Harnett County Department of Public Health

PERMIT # SFD2506-0004

Operation Permit

Duncans Creek Lot 39 "AS Built Revision" Harnett County

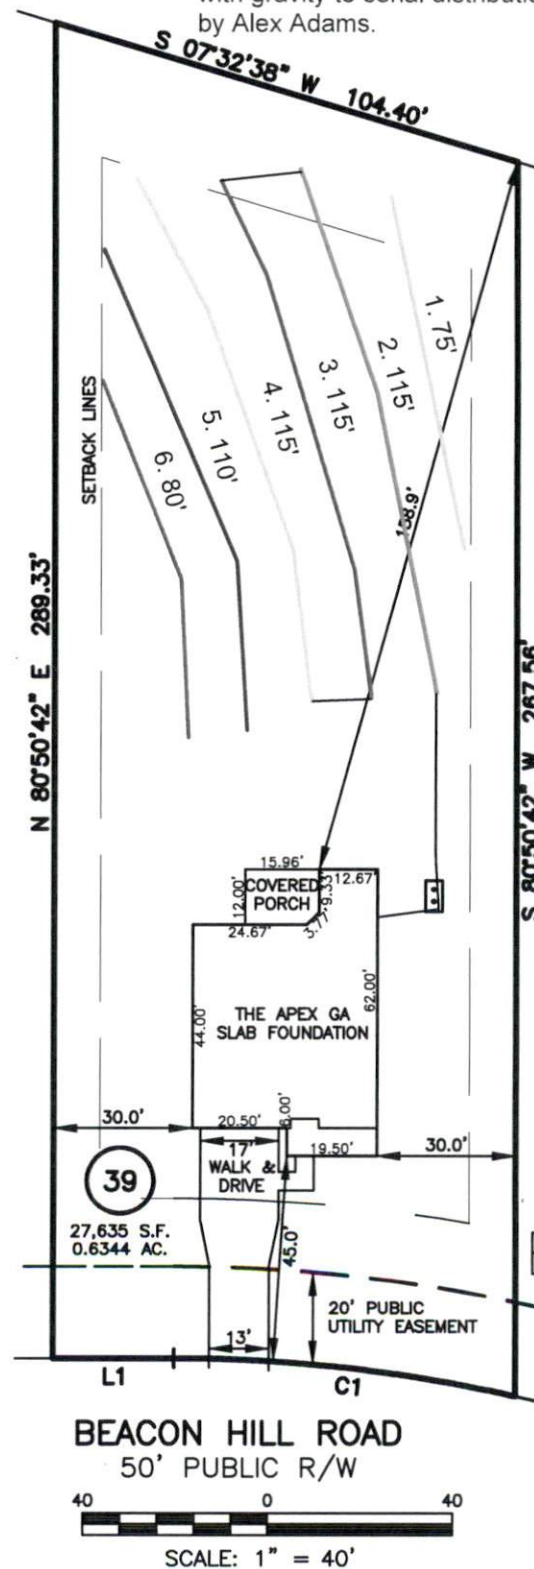
At time of installation septic installer was able to dose septic field with gravity to serial distribution. This system modification is Approved by Alex Adams.

INITIAL:
Lines 2-4 (345')
Accepted Status
serial distribution
REPAIR:
Lines 1,5-6 (270')
PPBPS
Pressure Manifold
